## F50V Series: Firmware v3.6.2 Release Notes

### Summary

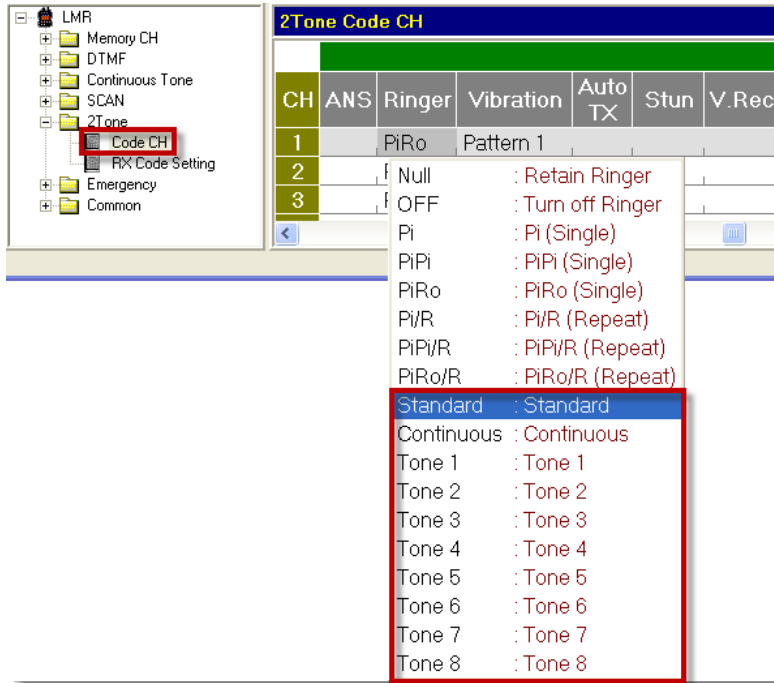
- Go to **2Tone** -> **Code CH** and select any of the new ringer settings.

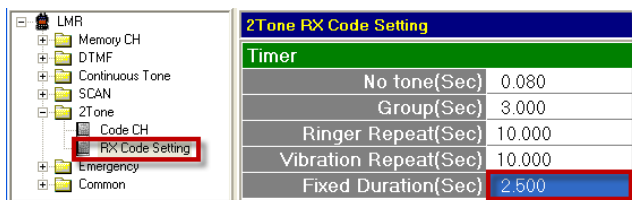
- Enter the duration you want the tone to ring. It can be set to 0.500sec to 10sec in 0.500sec steps.
